Model: Adonis-P		Date: 31-Oct-99	No.: MG035001
Modified Article: Parts Catalog Correction		Prepared by: K. Takagi	
From: Technical Service Dept., GTS Division			
Reason for Modification:	<input checked="" type="checkbox"/> Parts catalog correction	<input type="checkbox"/> Vendor change	<input type="checkbox"/> To meet standards ()
	<input type="checkbox"/> To facilitate assembly	<input type="checkbox"/> To improve reliability	
	<input type="checkbox"/> Part standardization	<input type="checkbox"/> Other

Model: Adonis-P		Date: 13-Aspr-00	No.: MG035002
Modified Article: Hot Roller Stripper and Tension Spring		Prepared by: K. Takagi	
From: Technical Services Dept., GTS Division			
Reason for Modification:	<input type="checkbox"/> Parts catalog correction	<input type="checkbox"/> Vendor change	<input type="checkbox"/> To meet standards ()
	<input type="checkbox"/> To facilitate assembly	<input checked="" type="checkbox"/> To improve reliability	
	<input type="checkbox"/> Part standardization	<input type="checkbox"/> Other

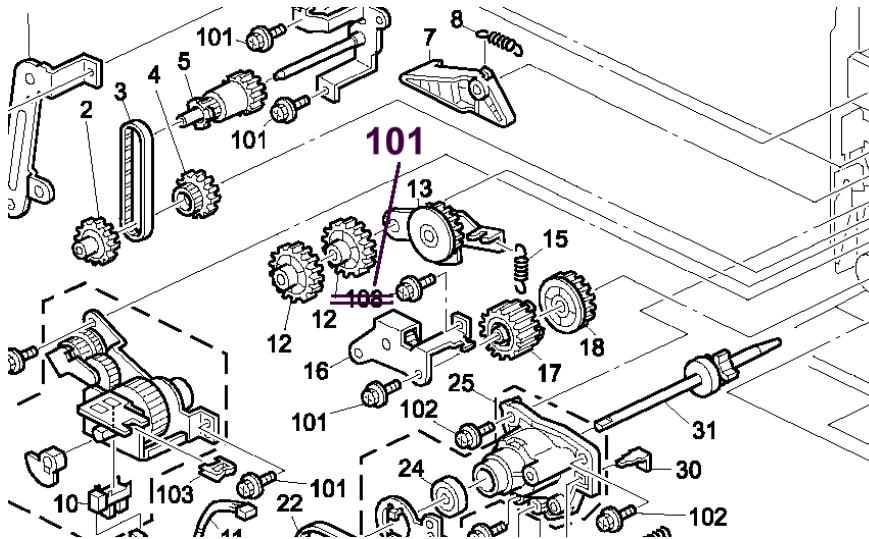
- Adonis-P (G035): Page 10
Add index number 34 as follows

- Adonis-P (G035): Page 25
Add the following part number for index number 1

Index No.	Part No.	Description	Q'ty
1	A2327266	Toner Supply Unit – 115V (RIC)	1

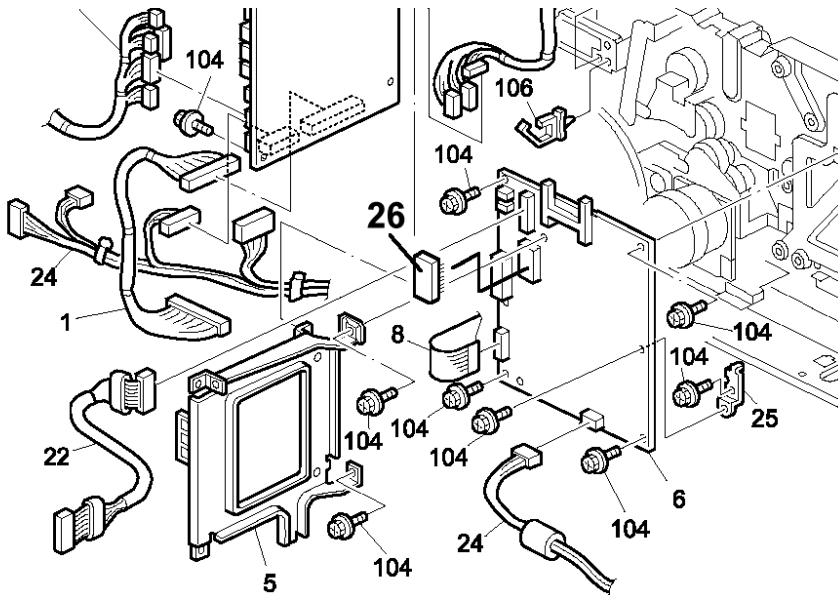
4. Adonis-P (G035): Page 52 and 53
Add NV-RAM (index number 26) and part number as follows

Index No.	Part No.	Description	Q'ty
26	A2849001	NV-RAM - +1000 Counter	1

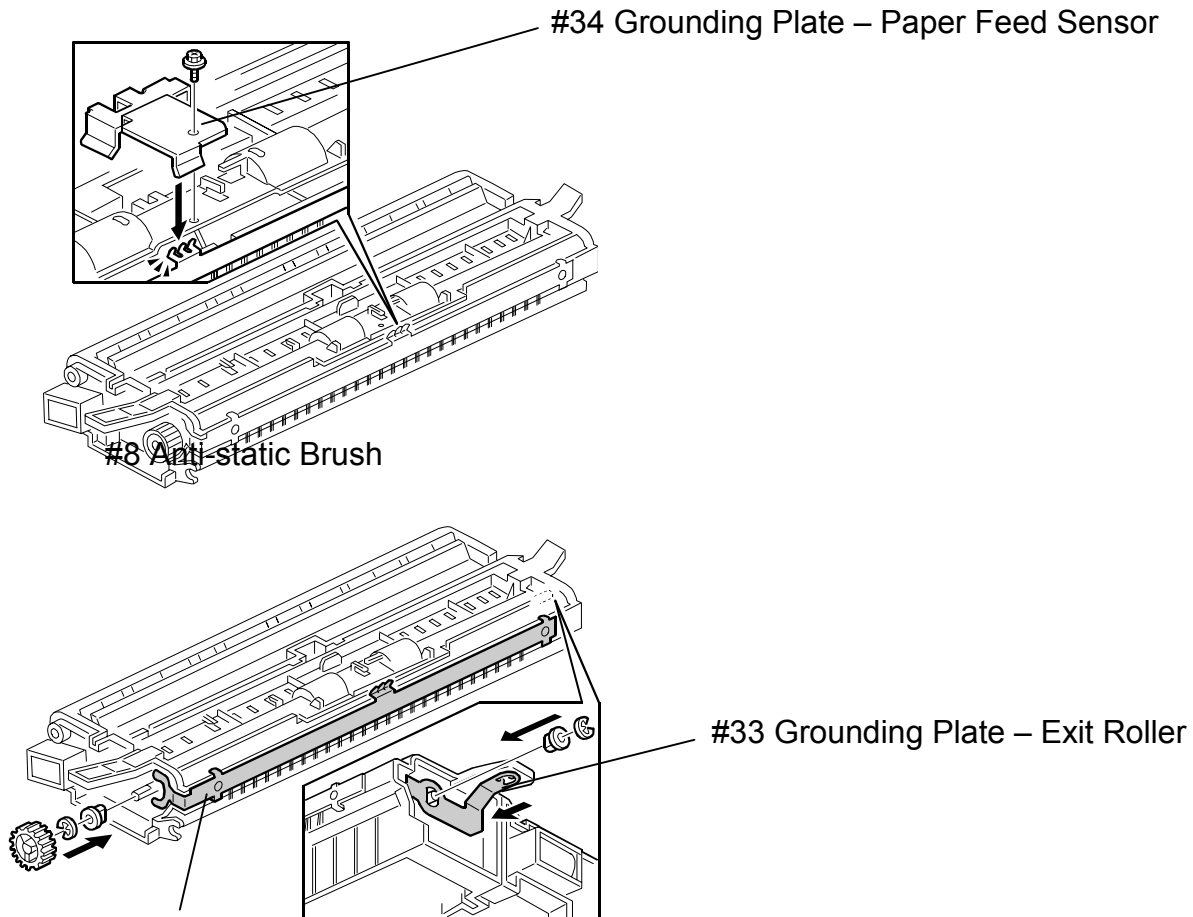
To ensure proper grounding, the shape of the anti-static brush has been changed and grounding plates for the exit and paper feed rollers have been added. Please refer to the illustration below. This modification reduces the occurrence of paper jams caused by static electricity buildup.

Old part number	New part number	Description	Q'ty	Int	Page	Index	Note
AA120089	A2844460	Antistatic Brush	1-1	X/O	39	8	
	A2844462	Grounding Plate – Exit Roller	0-1	-	39	*33	
	A2844463	Grounding Plate – Paper Feed Sensor	0-1	-	39	*34

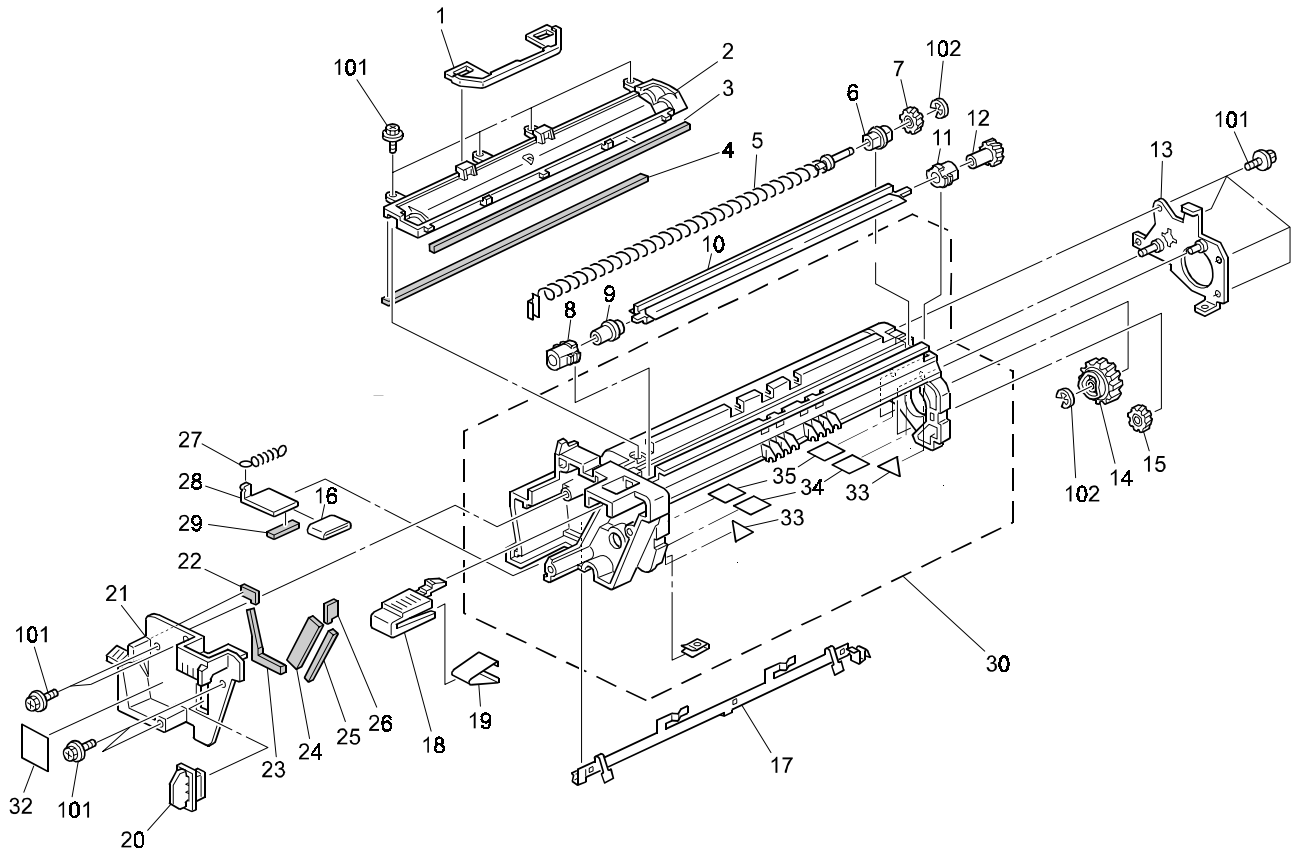
The following part has been registered as a service part.
Please add this to your parts catalog.

Old part number	New part number	Description	Q'ty	Int	Page	Index	Note
-	A2322350	Seal - Entrance	2	-	27	33	
-	A2322399	Seal - Blade 13 x 9.5 x 3	2	-	27	34	
-	A2322348	Seal - Blade 12 x 7 x 3	2	-	27	35

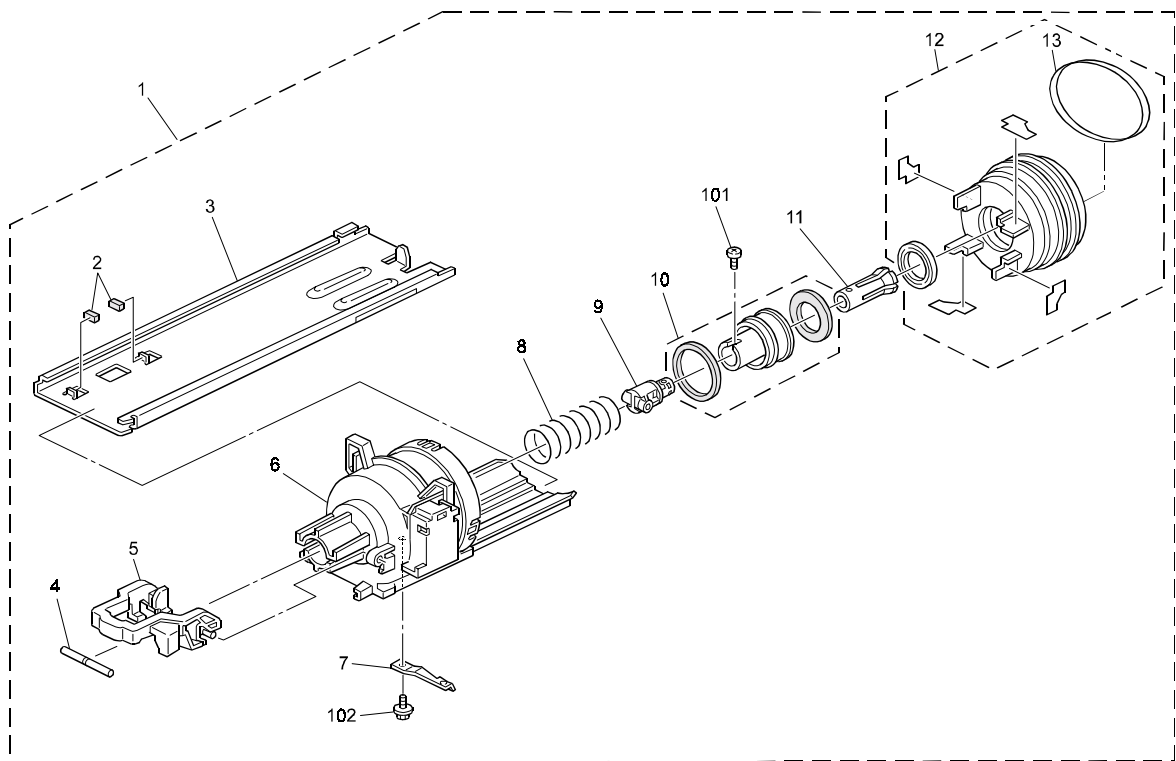
The connection between the toner supply unit and toner bottle is loose, which causes the unit to separate from the bottle when the unit is pulled out. Toner then spills out onto the toner supply unit and sometimes onto the front cover as well.

A seal has been added to the inside of the toner supply unit to minimize the freedom of movement of the toner bottle. This will tighten the hold of the toner supply unit on the bottle, preventing any separation of the bottle from the unit.

Old part number	New part number	Description	Q'ty	Int	Page	Index	Note
-	AA153083	Seal – Toner Supply Unit Cover (RIC NA)	1	-	25	13	
-	AA153084	Seal – Toner Supply Unit Cover (RIC EU and OEM)	1	-	25	13

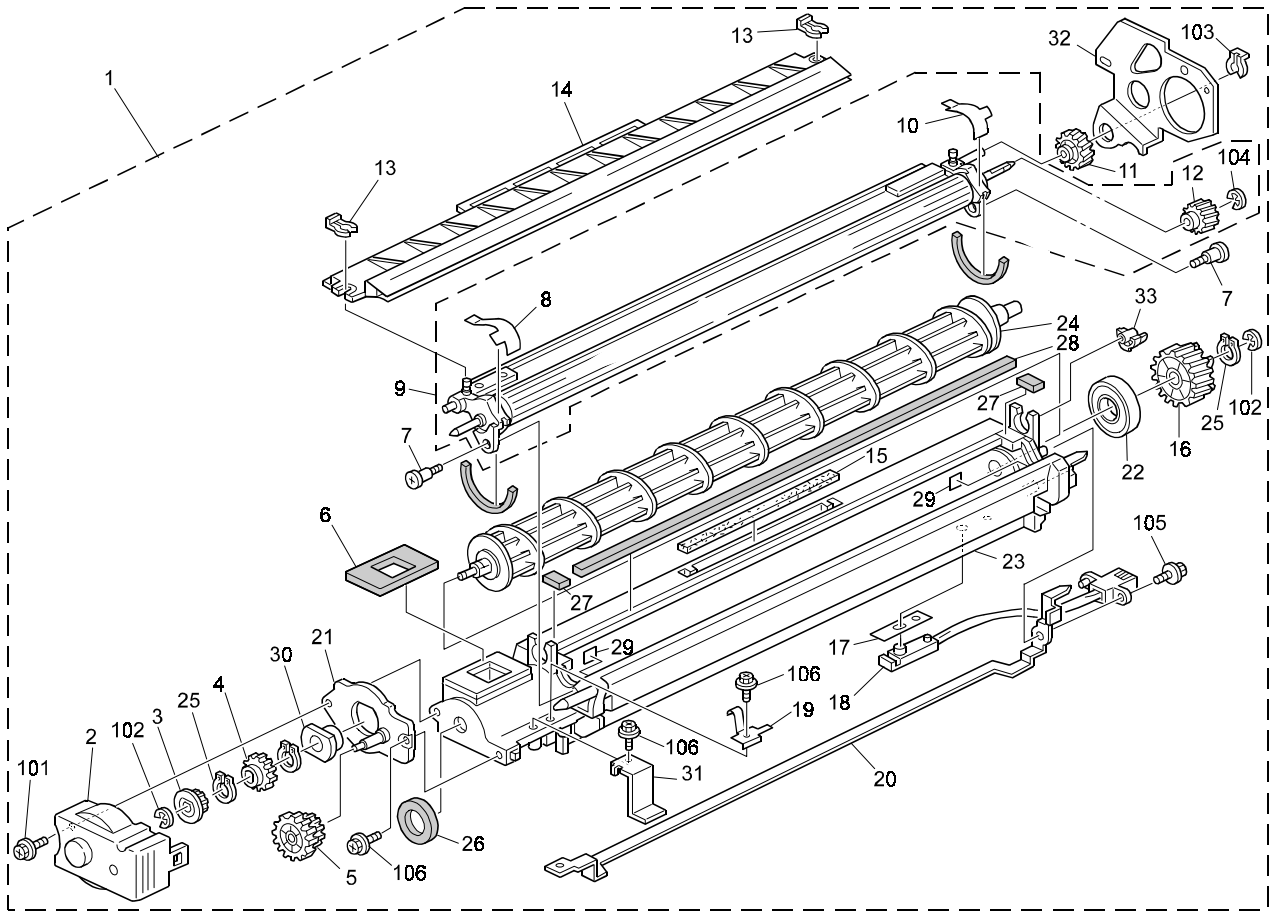
Due to the reasons listed below, the A2327460 Development Unit (NAD) will be used for the Adonis-P in place of the G0353050 Development Unit.

- The original Development Unit (G0353050) is filled with developer before it is shipped from the factory. The developer has a tendency to spill out during transport. However, the factory will not supply this unit without the developer.
- The Development Unit for the NAD (A2327460) can also be used with the Adonis-P if the three components listed below are installed.

When installing these three components in the A2327460 unit, you can either use the components from the original development unit (G0353050) or newly purchased components.

1. G0342450 (Index No. 32): Bracket – PCU and Development Unit
2. G0342451 (Index No. 31): Bracket – Development Stay
3. 04503010B (Index No. 106): Tapping Screw – M3x10

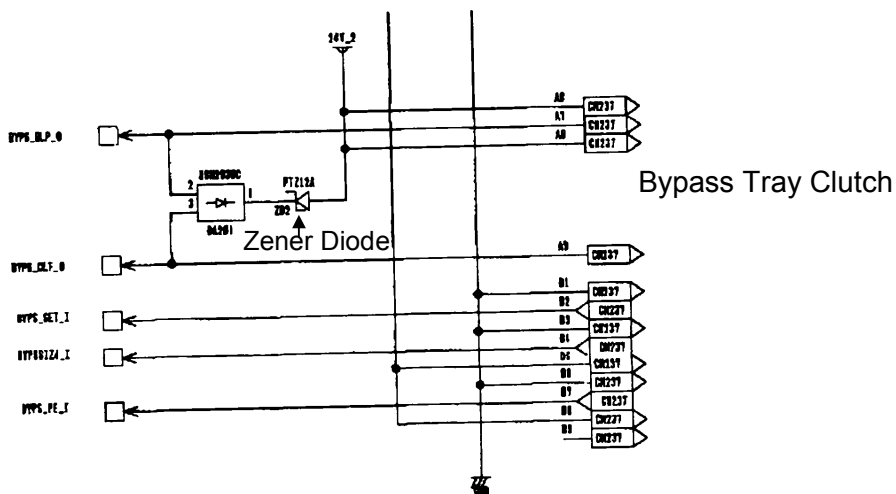
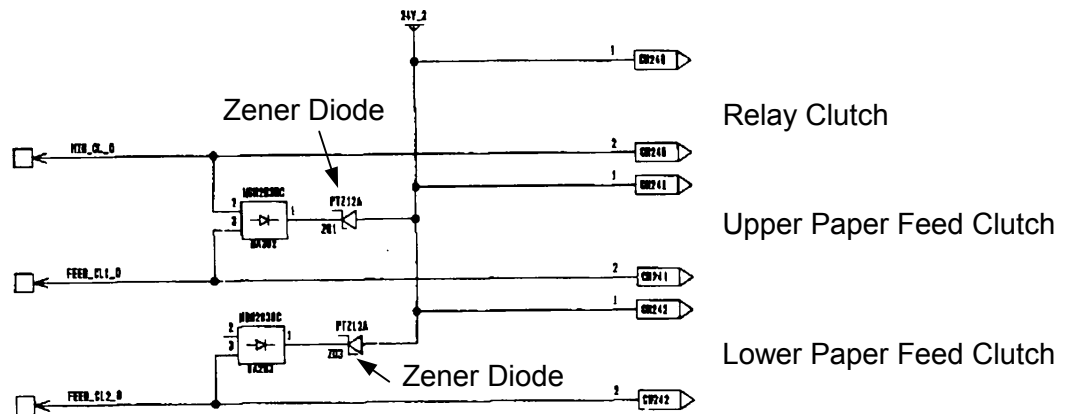
A counter electromotive force flows through the clutch drive circuits and causes the off-timing of the clutch to be delayed. This can result in a paper jam.

A zener diode has been added to the drive circuits of the PFB board for the following clutches, preventing any counter electromotive force from flowing through the circuits:

Old part number	New part number	Description	Q'ty	Int	Page	Index
A2325130	A2325135	PFB Board	1-1	X/O	49	20

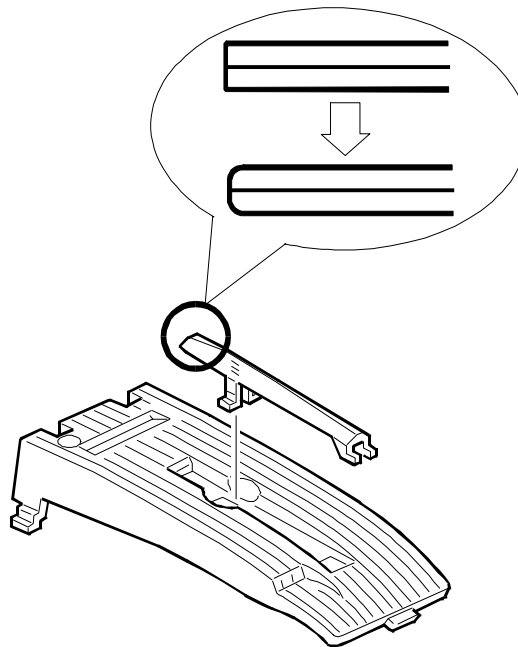
The edge of the copy tray guide has been rounded to ensure that scratches or other minor injuries do not occur.

Old part number	New part number	Description	Q'ty	Int	Page	Index	Note
A2324498	A2844498	Copy Tray Guide	1	X/O	11	2
